PEDESTRIAN WIND ENVIRONMENT STATEMENT

ARTHUR PHILLIP SCHOOL, PARRAMATTA

WC769-01AF03(REV1) - WS REPORT

21 MARCH 2016

Figure 3: Potential Treatments – APHS Upper Ground Level

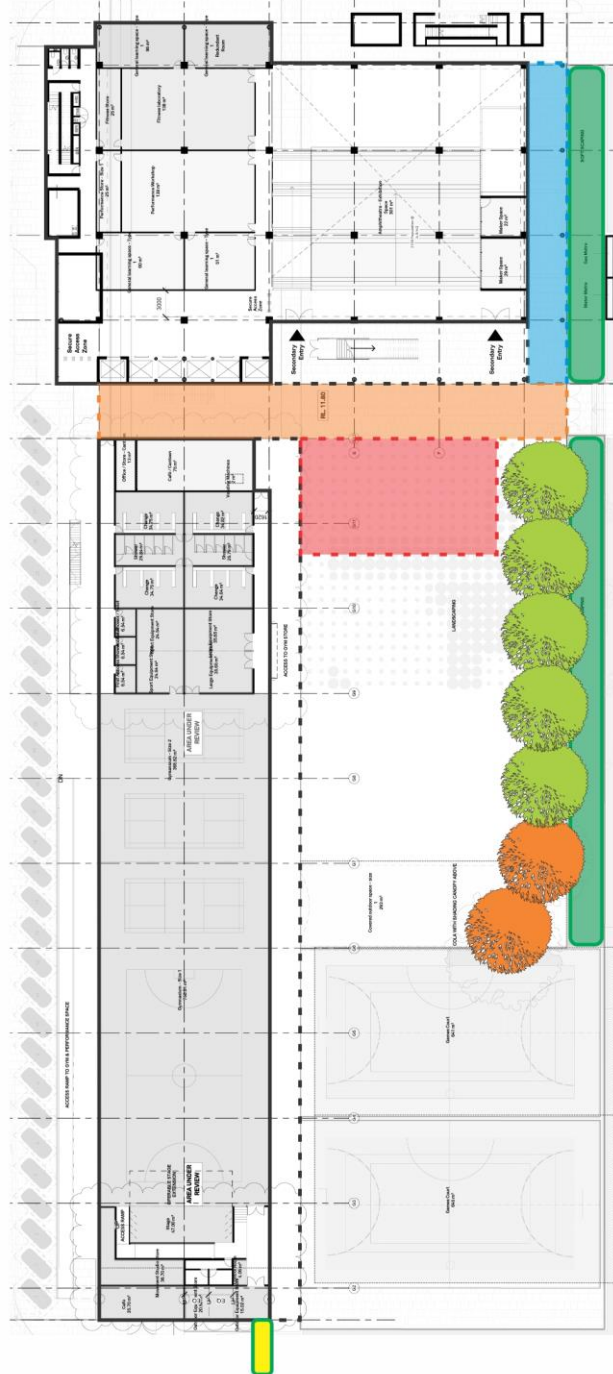
The café on the corner of the future road and Barrack Lane is exposed to the dominant southerly wind and will likely experience unfavourable conditions as this southerly wind is accelerated around the eastern side of the development. A potential remedy for this undesirable flow effect would involve installing a line of densely foliating evergreen trees 3m in height, or extending a blade wall eastward on the southern aspect in order to baffle the southerly winds approaching the café. This is shown at the bottom of Figure 3 on page 12.

The north/south thoroughfare that runs between the gymnasium and the building is susceptible to both southerly and westerly winds. This passage would have the effect of funnelling incident airflow from these two directions through this corridor and would likely be uncomfortable for frequent pedestrian usage. In addition, the secondary entrances on the western base of the building are exposed to a similar effect from westerly winds. The potential detrimental effect of these winds could be minimised for both cases by including an overhead canopy on the east-most side of the outdoor recreational area. Similarly, the extension of an awning over this region, level with the gymnasium roof, will also help to mitigate undesirable wind conditions around this upper ground floor region. These potential treatments are shown in Figure 3.

The downhill stepped walkway on the southern aspect that runs parallel to Macquarie Street is also exposed to the westerly wind. The soft scaping as depicted in the architectural drawings should consist of low level vegetation around 1m in height. Similarly, an awning extended out from the level 01 floor slab over this area will also serve to mitigate any undesirable wind effects. These potential remedies are also indicated in Figure 3.

The outdoor recreational area will benefit from the retention of existing trees as described in the architectural drawings, and a line of densely foliating trees along the soft scaping parallel with Macquarie Street will further improve the wind comfort in this area. These trees will also have the effect of baffling winds approaching the western secondary entrances and north/south thoroughfare, and are shown in Figure 3.

-  Soft scaping should be low level vegetation around 1m in height
-  Existing trees to be retained
-  Densely foliating trees
-  Canopy over yard (Covered Outdoor Learning Area)
-  3m tall blade wall or row of similar height dense vegetation
-  Awning attached to adjacent buildings, level with Level 02 floor slab
-  Awning attached to adjacent building, level with Level 01 floor slab

Figure 4: Potential Treatments – PPS Level 01

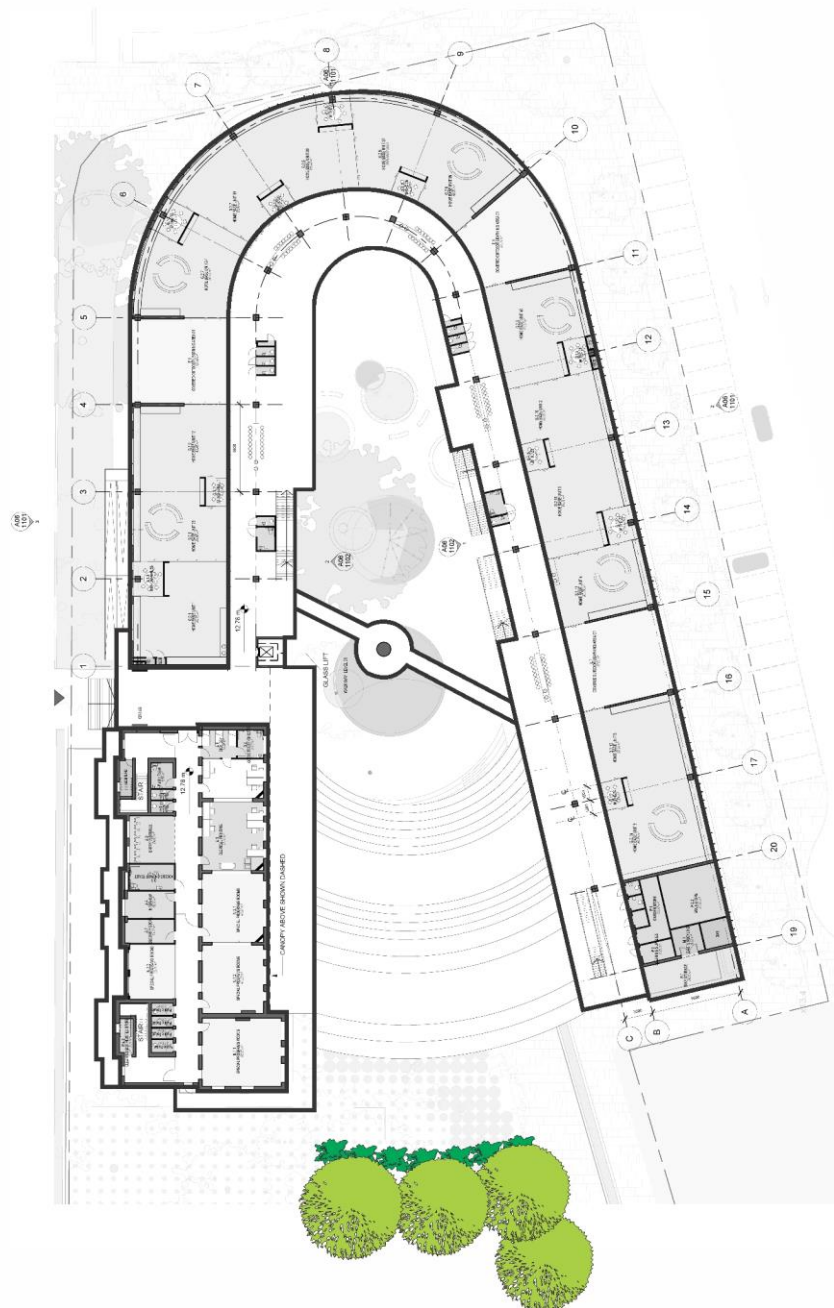
This outdoor area is inherently sheltered from southerly and north-easterly winds by the development itself. To minimise exposure to the westerly winds however, it will be necessary to ensure densely foliating evergreen trees as well as lower level vegetation are strategically planted to shield the western entrance to this area so as to baffle approaching westerly winds. Details of these potential treatments are shown in Figure 4.

Densely foliating evergreen trees capable of growing to a height of 15-20m

1-1.5m hedges or similar height evergreen vegetation, at the tree baseline

Figure 5: Potential Treatments – PPS Rooftop

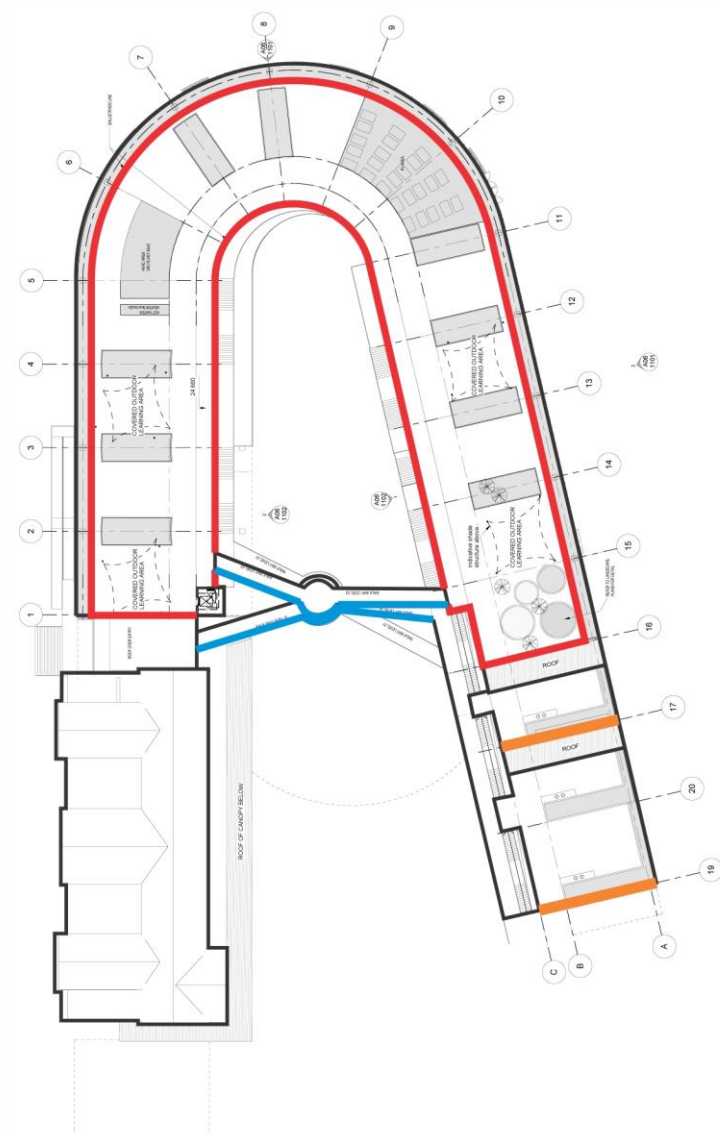
The garden balconies on Levels 2 and 3 are exposed to westerly winds. To ensure comfortable wind conditions in these areas, 1.8m perforated metal screens with no higher than 40% permeability should be installed along the western edge of these garden terraces, as shown in Figure 5.

The open air internal walkways and connecting stairways on the inside of the development should be suitable for frequent pedestrian use. These areas will benefit from the overhead canopies between each level which should provide effective shelter from winds. The overhead walkways that span the courtyard however, are likely to be more prone to westerly winds as they are more exposed in this direction. To ensure adequate shielding for these areas, it would be necessary to ensure that the trees planted immediately west of the assembly area, are capable to reach a 15-20m height so as to shield the top Level 3 walkway. Alternatively, 1.8m perforated metal screens with no higher than 40% permeability, on the western sides of the Level 2 and 3 overhead walkways would also effectively shield pedestrians using these overpasses. These recommended treatments are highlighted in Figure 5.

- 1.8m perforated metal screens with no higher than 40% permeability
- 1.8m perforated metal screens with no higher than 40% permeability on the western edge of the Level 2 and 3 walkways
- 1.8m perforated metal screens with no higher than 40% permeability on the western edge of the Level 2 and 3 outdoor garden terraces
